August 15, 2018

To: Town of Wayland- Conservation Commission
Ms. Linda Hansen
41 Cochituate Road
Wayland, MA 01778

Re: Response to comments at hearing and updated WPA Performance Analysis, **NOI, 24 School Street**

USGS monitoring well WKW 2 Wayland water table chart.

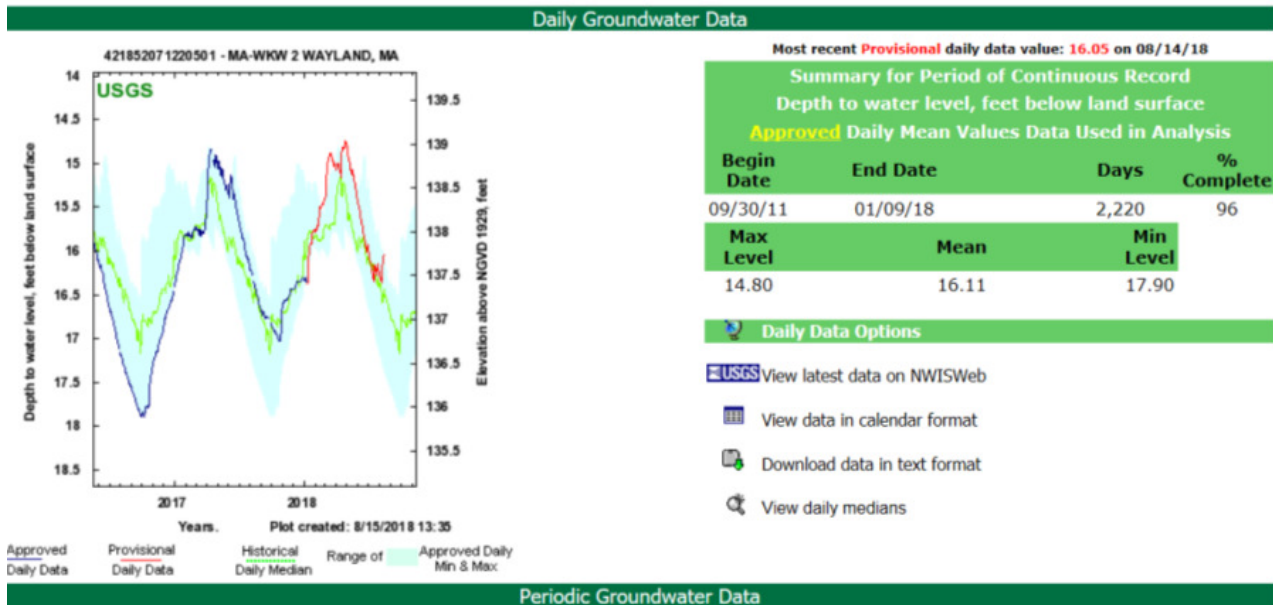
At the August 9, 2018 public hearing, the Commission requested that 1) some additional information about USGS monitored groundwater table in the high water season (March – May), 2) provide an update of the WPA Performance Analysis. The neighbor, Mr. George Bernard's Attorney, Mr. Wiggins spoke on behalf of Scott Horsely, concerning the long term accumulative groundwater elevation impact. This letter provides the requested information and presents our responses.

We checked USGS monitoring well WKW 2 in Wayland, which would be located in the same weather zone. The monitoring data showed that the water table recorded on 3/12/2018 is 14.94 ft from grade, while the highest water table recorded in April 2018 is 14.75 ft (4/28/2018), and in May 2018 is 14.79 ft (5/2/2018). As a standard practice, USGS normally only take one reading in a month, which would carry a margin of error 6-7". The high water table we caught in March is only 0.19' or 2.28" from the highest point, which would be considered well acceptable in groundwater monitoring. See the following chart from USGS Website. The 2018 water table recorded exceeded the history high 14.80' at the USGS monitoring well. If the project has been done in 2016, the highest water table monitored would be more than 6" lower than what we had for this year. The detailed data is presented in Appendix A.
